SUBJECT: U.S. NUCLEAR REGULATORY COMMISSION STAFF ACCEPTANCE REVIEW  
OF THE HOMESTAKE MINING COMPANY OF CALIFORNIA REQUEST FOR  
AMENDMENT TO LICENSE SUA-1471 FOR THE LARGE TAILINGS PILE  
EVAPOTRANSPIRATION COVER DESIGN DOCKET NO. 04008903

**U.S. Nuclear Regulatory Commission Comments  
Homestake Mining Co. of California, Grants Reclamation Project  
Large Tailings Pile Evapotranspiration Cover  
License Amendment Request**

Figure 1. Dispersive Potential vs. Total Dissolved Salts (Source: Figure 4 of USBR, 1991)

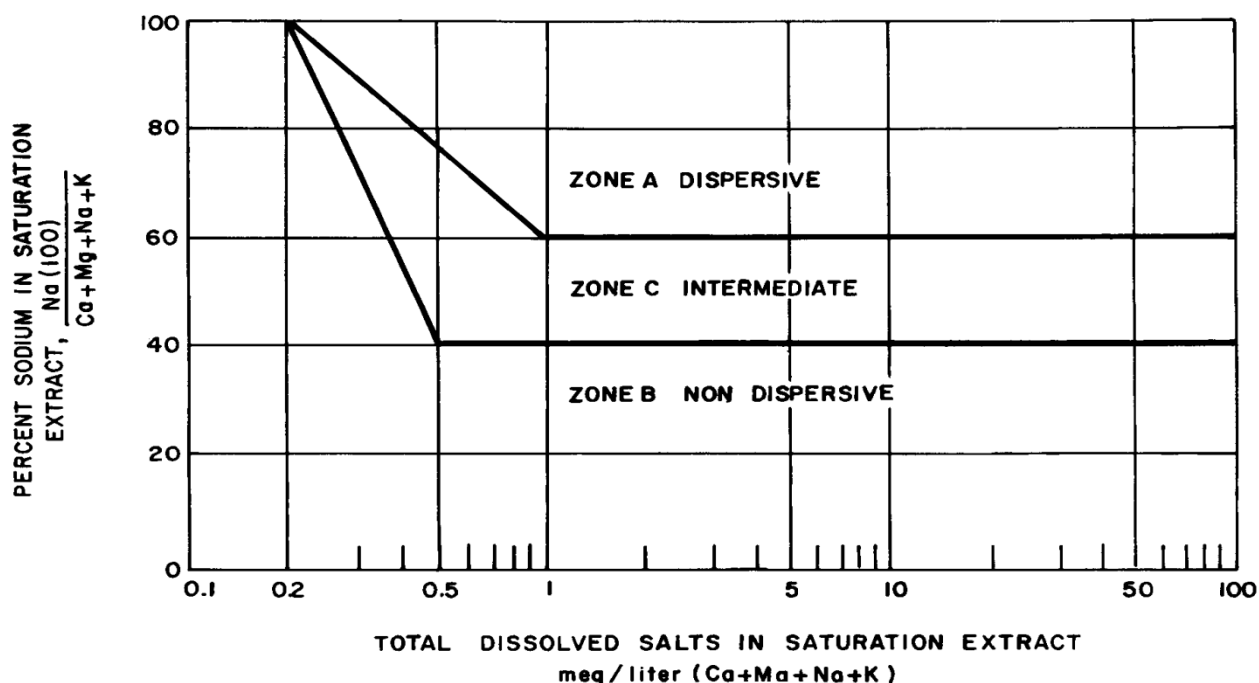
Dispersive soils are prone to water erosion (leading to gully, piping) and compaction when wet (resulting in a reduction in soil pore space, which can restrict plant growth). The results of the borrow soil agronomic laboratory testing, provided in Table 2 of Appendix C of the LAR, suggest that most of the soils are dispersive. The pH of the 18 samples tested in Table 2 of Appendix C range from 7.76 to 10.01. According to Hauser (2009),<sup>2</sup> soils with pH of 8.3 and higher “may contain excess sodium, and at pH above 9, the soil probably contains excess sodium, which disperses both clay and organic matter” and that “few, if any plants grow in these soils.” Furthermore, using a relationship between percent sodium and total dissolved salts in saturation and dispersive potential (U.S. Bureau of Reclamation (USBR), 1991 (see Com 3-1, Figure 1))<sup>3</sup> indicates that samples TP1-A, B and C; TP2-D; TP3-B, C and D; TP4-D; TP5-B, C are dispersive. Samples TP2-A, B, C and TP5-A are characterized as having an intermediate dispersive potential, while only samples TP3-A and TP4-A, B, C are non-dispersive (see Com 3-1, Table 1, developed by the NRC staff based on data from the LAR).
